Administrative Approval Action

AA #3860 / S-13-18, Brier Creek – Aviation Pkwy South
Transaction# 549097

REQUEST: Subdivision of an 18.71-acre tract zoned CX-3-PK into 5 lots.

L1.0

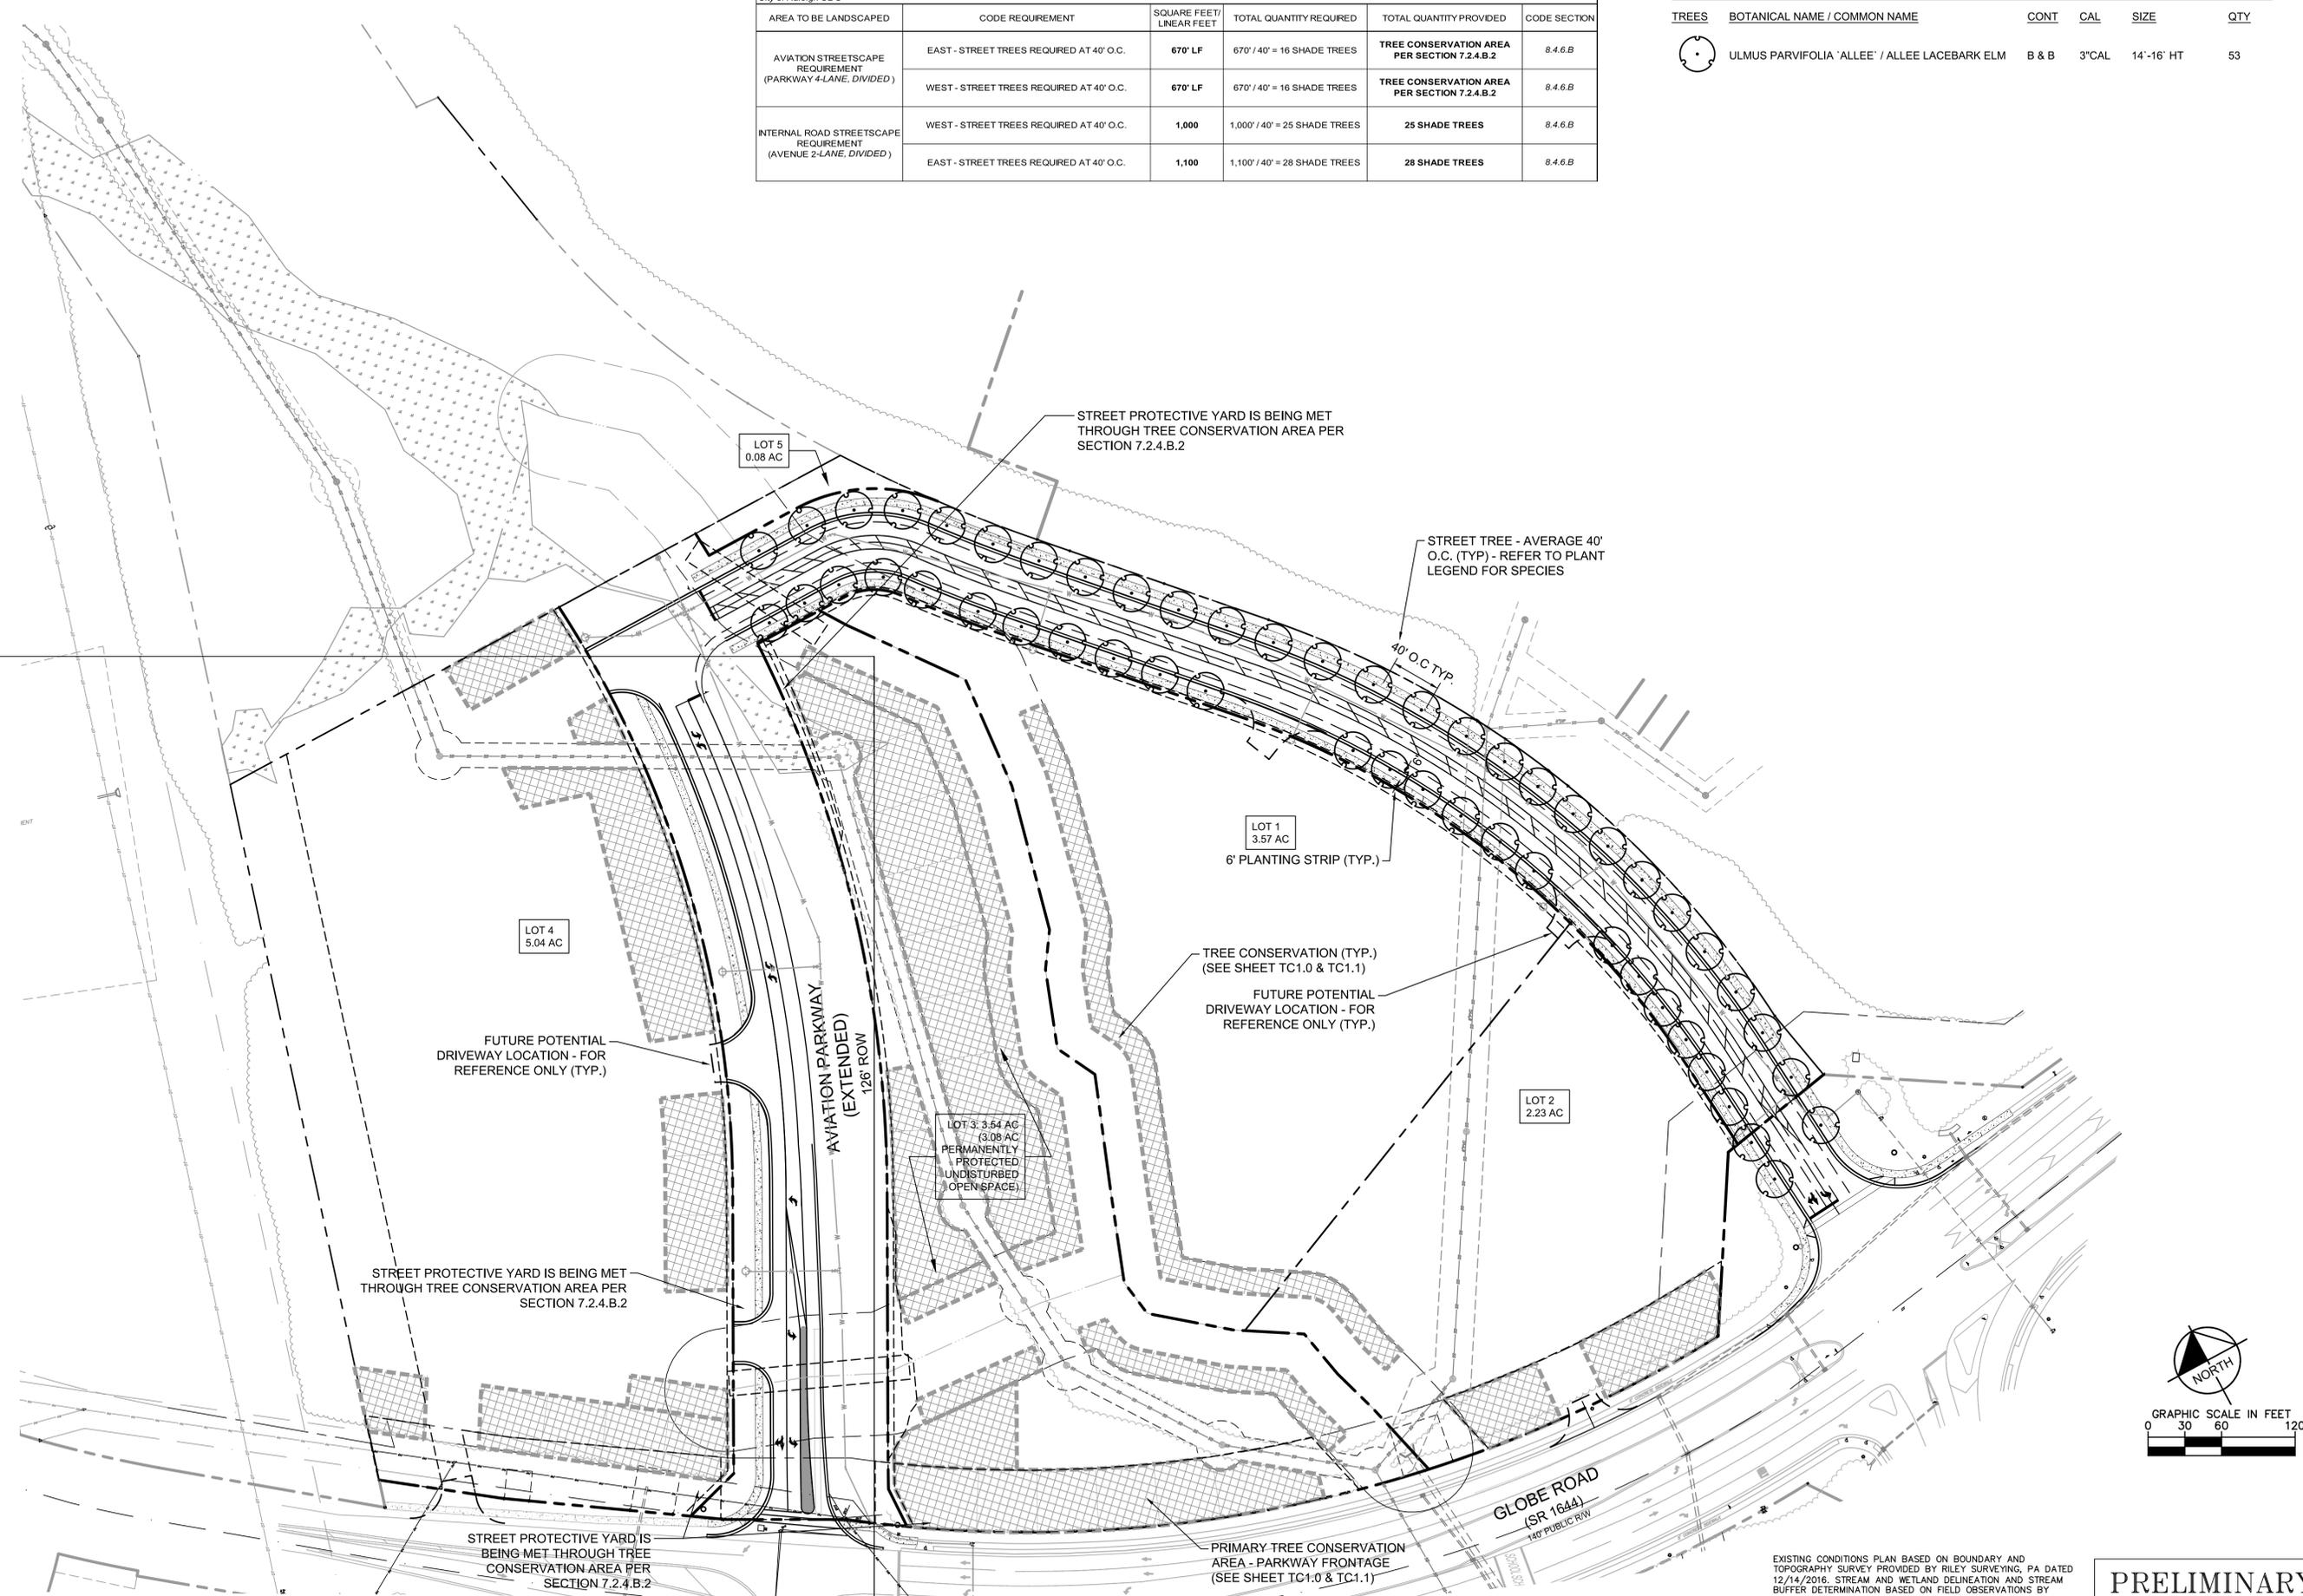
Staff supports the request for relief of the 5' Utility Placement Easement dedication along the proposed Confluence Dr which will be a City or Raleigh maintained Avenue 2-Lane, Divided street section.

Confluence Dr is being proposed along the northwestern property line. The street has been proposed and designed with an over-dedication of public right-of-way along the northern side of the road (5' of additional right-of-way). This is due to this development not controlling any property to the north and by over-dedicating, the 5' Utility Placement Easement can be recreated and all future utility placements can be placed in the same location, but while still being within the public right-of-way.

- Article 8.5 requires a 5' utility placement easement along the public street frontages. The design adjustment request applies to Confluence Way (new street) and Globe Rd. frontage.

- Confluence Way is proposed as a new street. The right of way line for this street is also the existing eastern property boundary; therefore, there is no land area within the control of this applicant where the easement can be placed. Thus, the utility (if required) is proposed to be within the new right of way.

- Confluence Way is proposed as a new street with center turn lane. The proposed right of way width for this street (81') exceeds the 79' requirement. This is proposed in order to avoid a non-conforming lot between the r/w and the adjoining residential lots to the east and to allow grading tie-outs within the proposed r/w.

1. The allowance of an alternative streetscape cross section waiving the required 5' utility easement outside of the right of way along the northwest property line. (Confluence Drive)
